# COPLEY TOWNSHIP MAJOR SITE PLAN VARIANCE STAFF REPORT

June 6, 2022

<b>PROJECT:</b> <b>Rosemont Ledges Subdivision*</b> <b>Parcel: 1508654</b> <i>*21 lots total. 2 Lots proposed in Copley Township.</i>	<b>APPLICATION TYPE: Major Site Plan &amp; Variance</b>
APPLICANT/LANDOWNER	APPLICANT: David M. Kolar-Cambridge Services, LTD LANDOWNER: Cambridge Services LTD
COMPANY PERFORMING WORK REQUESTED	TBD
INVESTMENT	2 Residential Homes (Valued \$400,000) per home
APPLICATION SUMMARY	<p>The applicant is proposing a new subdivision comprised of twenty one lots. Nineteen lots are located in the City of Fairlawn. Two lots are located in Copley Township.</p> <p>The proposed lots in Copley are located on Parcel 1508654. This parcel is zoned Residential-Medium Density. The parcel is 1.391 acres. The parcel will be split into two lots.</p> <p>Access for these lots will be located in the City of Fairlawn-Sawgrass Drive.</p> <p>The applicant will require the following variances for the proposed lot split:</p> <p>#6 Minimum Front Yard Setback from the Street Right-of-Way Line - Single and Two-family. Sixty (60) feet.</p> <p>#7 Minimum Rear Yard Setback - Single and Two-family. Fifty (50) feet.</p>

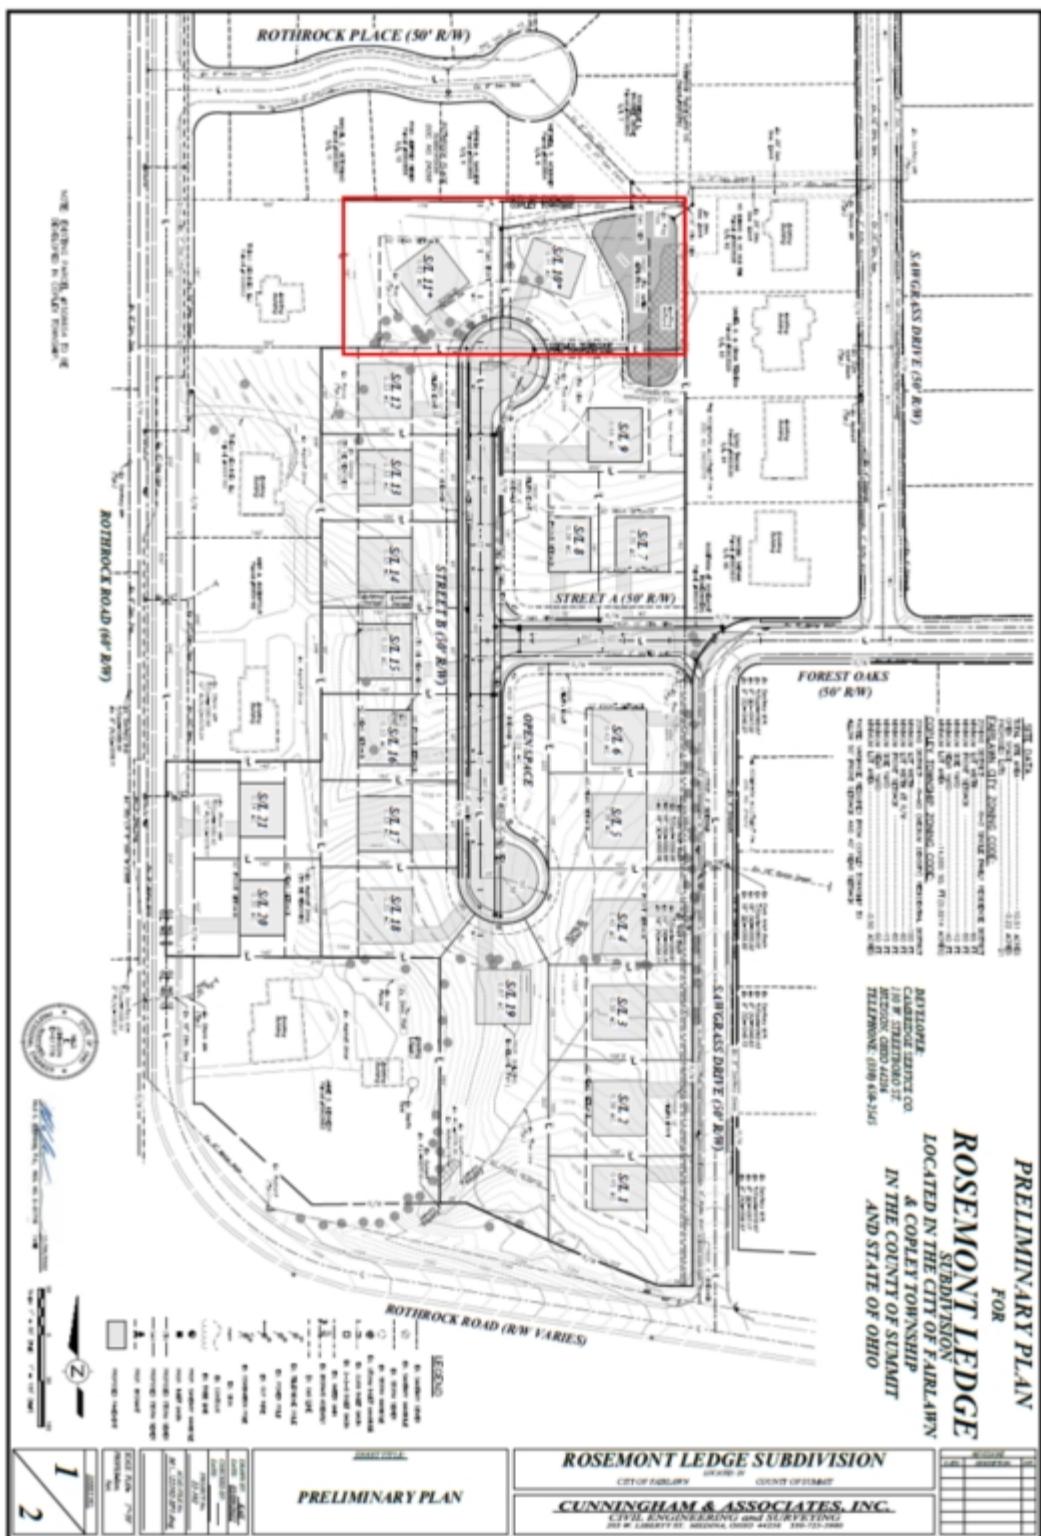
Copley Township Fire Department	<ul style="list-style-type: none"> <li>Copley will work with Fairlawn on mutual aid for this subdivision. Mutual Aid Agreement in place.</li> </ul>
Summit County Engineers Office	<ul style="list-style-type: none"> <li>The lot sizes appear to be reasonably sized. The lots have adequate access. Recommend a mutual services agreement.</li> </ul>

<b>Copley Township Service Department</b>	<ul style="list-style-type: none"> <li>• No major issues anticipated.</li> <li>• Require that Fairlawn maintain the portion of the road inside Copley Township for snow, ice control, stormwater and road maintenance</li> <li>• Trash Collection-Copley Township utilizes Republic for Township wide collection service. Requirement for this portion to be determined.</li> <li>• Further information required regarding maintenance and ownership of basin and sidewalks.</li> </ul>
<b>Copley Township Police Department</b>	<ul style="list-style-type: none"> <li>• No major issues anticipated.</li> <li>• One immediate concern is that the response to the homes in Copley could be delayed due to the closing of Rothrock Road. Fairlawn officers responding to that development would most likely travel there via Rothrock Road (and would have access before the delineators) or through Rosemont Blvd. Copley officers could come from those areas, as well. However, since our officers spend a significant amount of time in Montrose, our response to an emergency in that area would often be quicker via Rothrock Road, only after traveling through the delineators, or via Rosemont after activating the gate. The gate would delay our response slightly because the gate must first be radio activated, which sometimes takes a couple tries, and then the officer would have to wait for the gate to rise. Responding through the delineators can cause damage to police cars as well.</li> </ul>

<b>Summit County Planning –Review for Minor Site Plan Approval</b>	<ul style="list-style-type: none"> <li>• While my office has not yet received an official application for the Minor Subdivision we have been in touch with the applicant and their surveyor, and have seen preliminary drawings of the proposal. My office does not have any opposition to the proposed minor subdivision based on the preliminary PDFs we have received.</li> </ul>

- Access to the parcels in Copley Township are restricted due to the road closure on Rothrock Road.
- In the City of Fairlawn, the installation of sidewalks are the responsibility of the homeowner.

- Proposed development is complimentary to surrounding residential neighborhood and serves as an appropriate buffer to commercially zoned land.

- Tree removal is required for the proposed development. The topography of the land is challenging and requires adequate storm water management to mitigate water runoff.

Zoning Requirement Area & Height Regulations R-MD	PROPOSED	NOTES
Minimum Lot Area ½ acre	Lot 10: 0.71 Acre Lot 11: 0.62 Acre	MEETS REQUIREMENT
Minimum Lot Width at the Building Setback Line 100'	Lot 10: 200' Lot 11: 176'	MEETS REQUIREMENT

Minimum Lot Width from the ROW continuing to the building setback line: 60'	Lot 10: 63' Lot 11: 62'	MEETS REQUIREMENT
Minimum front yard setback: 60'	Lot 10: 50' Lot 11: 50'	10' VARIANCE REQUIRED  What is the required front yard setback for this development in the City of Fairlawn
Minimum rear yard setback: 50'	Lot 10: 40' Lot 11: 40'	10' VARIANCE REQUIRED  What is the required rear yard setback for this development in the City of Fairlawn
Minimum side yard setback: 15'	Lot 10: Lot 11:	Please indicate setback on plan

The Copley Township Architectural Review Board recommends approval contingent upon final approval of the Minor Subdivision Application from Summit County Planning and the Final Site Plan from the City of Fairlawn.

Approval for applicant to apply the Subdivision Regulations from the City of Fairlawn to make the subdivision harmonious and uniform in design and landscape inclusive of the City of Fairlawn's Landscape Chapter 1296.

Recommend mutual aid agreements for Service, Fire and Police as available and overseen by those departments.
